**PRELIMINARY DRAINAGE REPORT
FOR
JUDGE ORR ROAD COMMERCIAL PARK
EL PASO COUNTY, COLORADO**

May 2025

JR ENGINEERING
5475 Tech Center Drive
Colorado Springs, CO 80919
(719) 593-2593

Job No. 25315.00

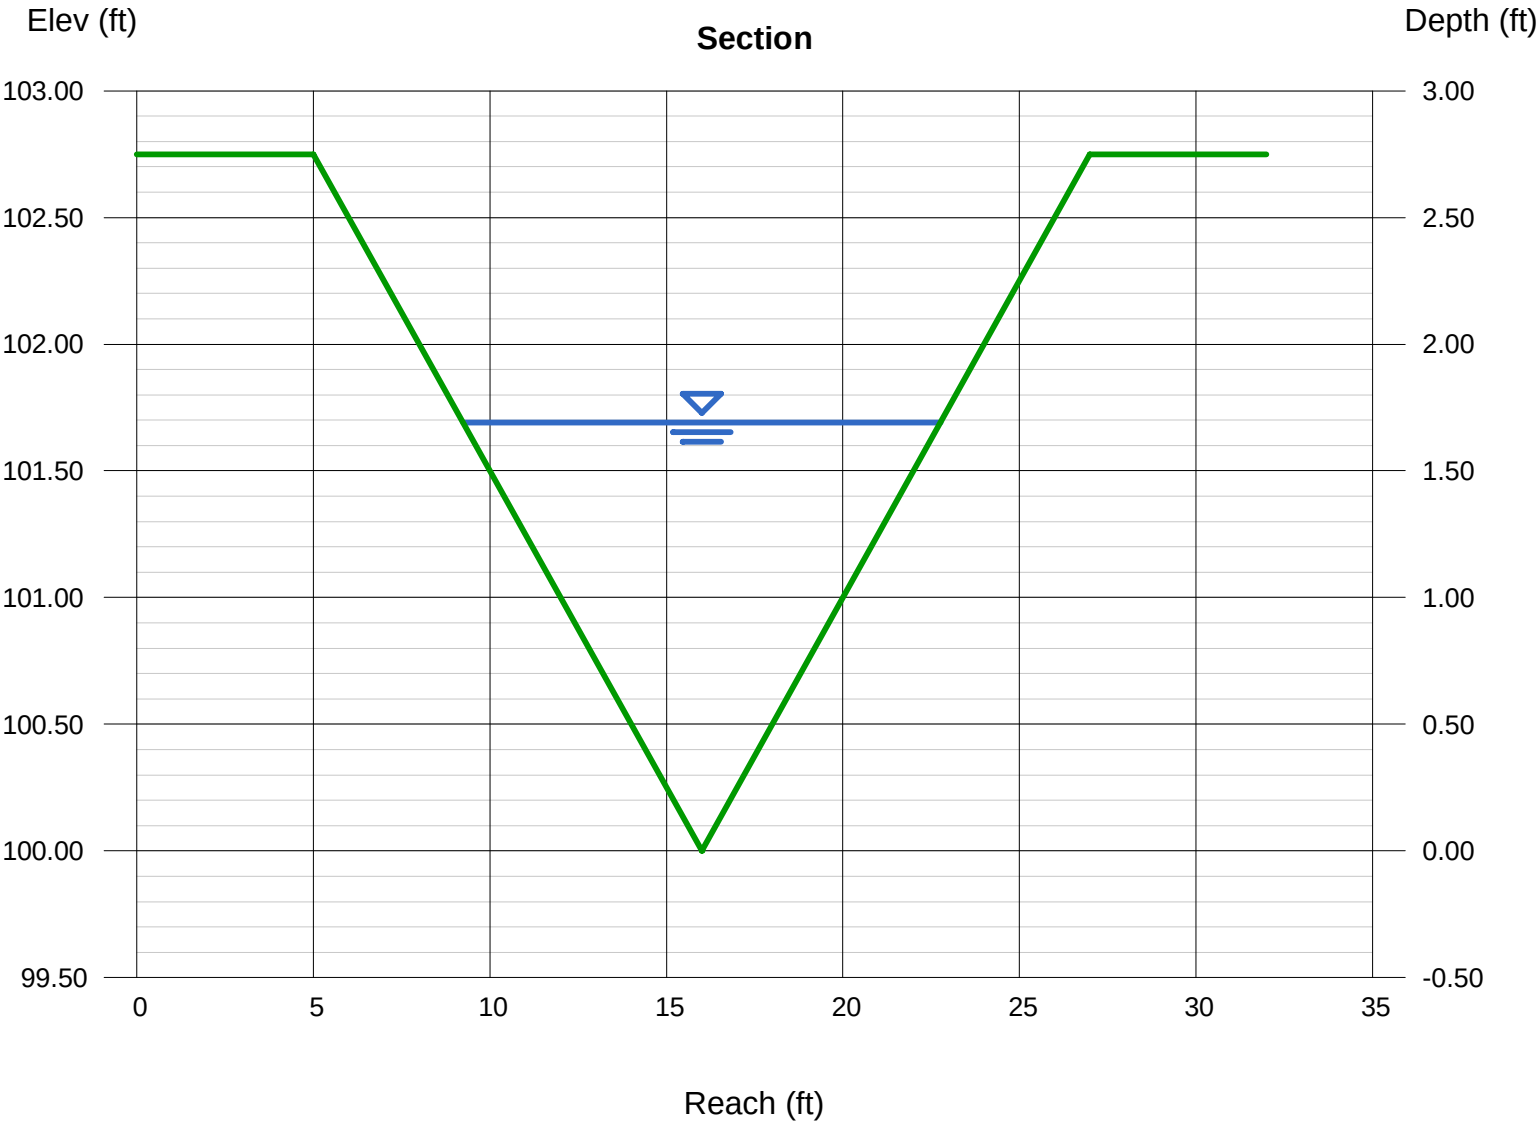
Note velocity is high. Lining may be needed, but this can be determined at FDR. Just add a footnote here stating that.

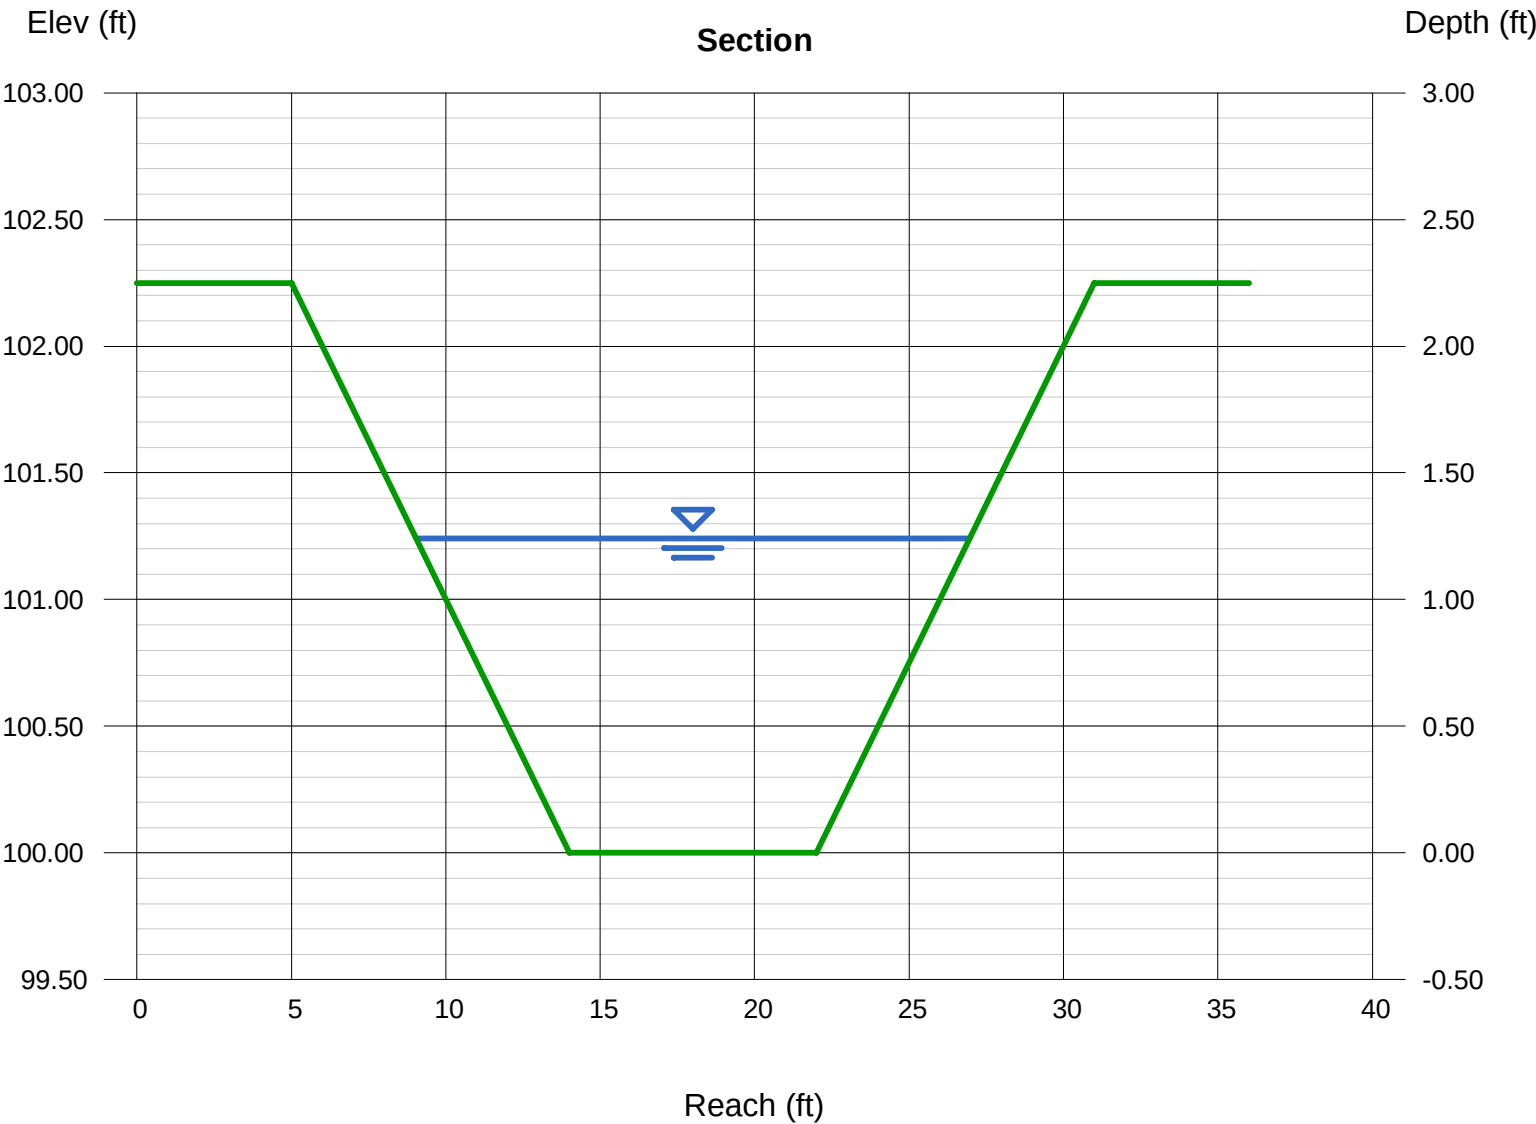
Flow at O3
is 63.5 cfs

PROPOSED DRAINAGE MAP

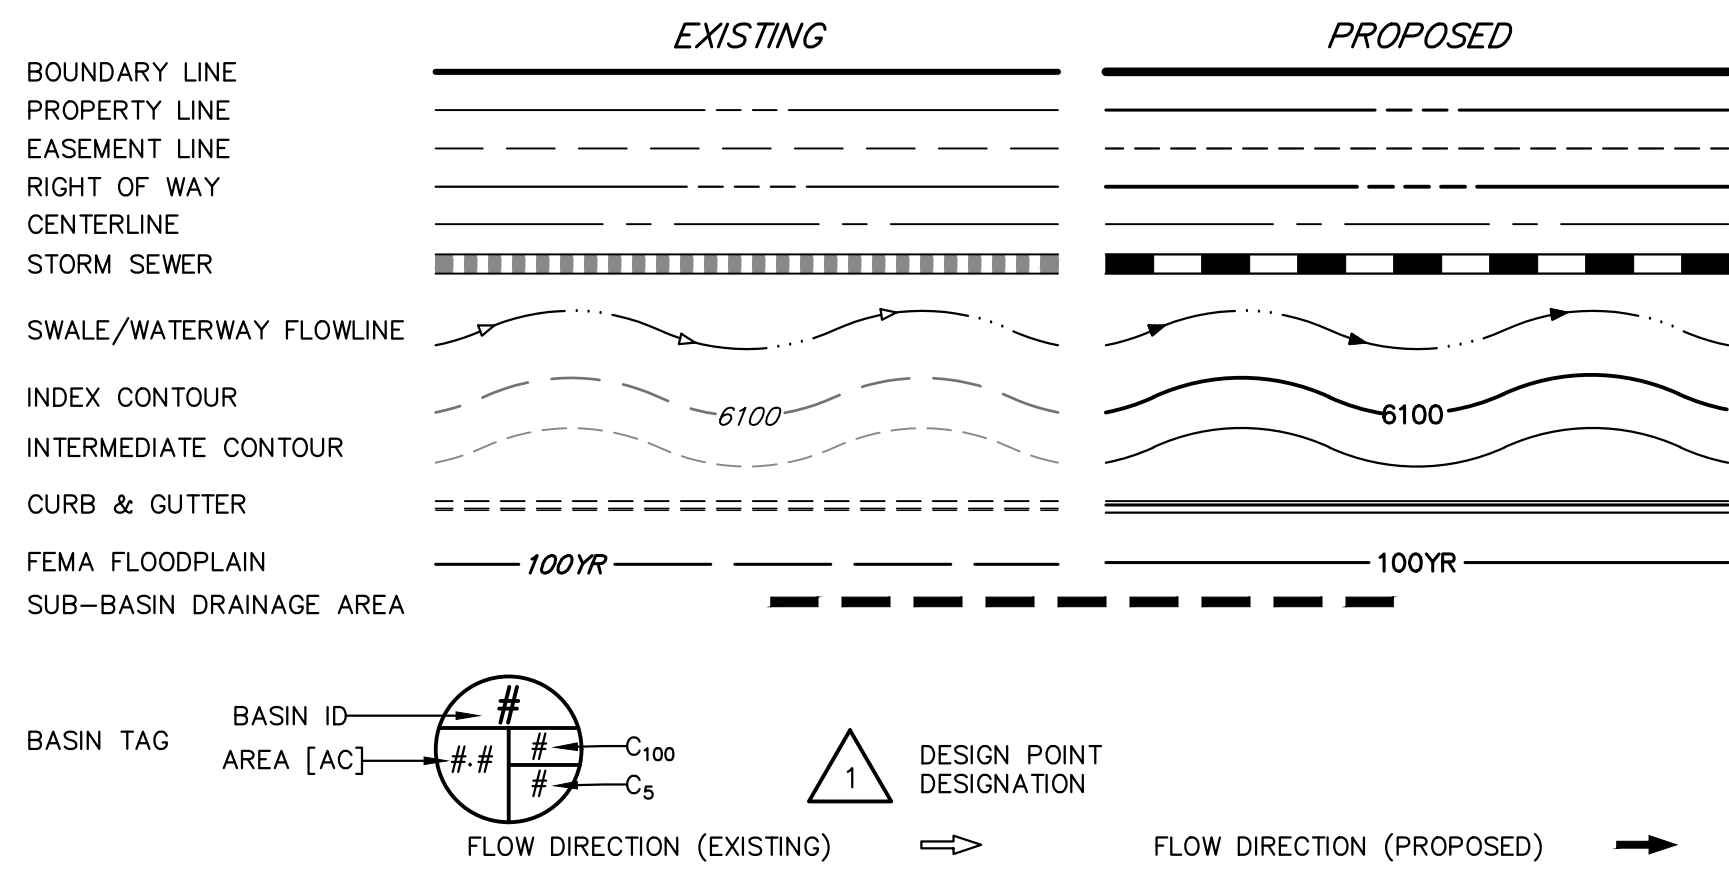
Note velocity is high. Lining may be needed, but this can be determined at FDR. Just add a footnote here stating that.

Ensure all tracts are shown and match with preliminary plan.
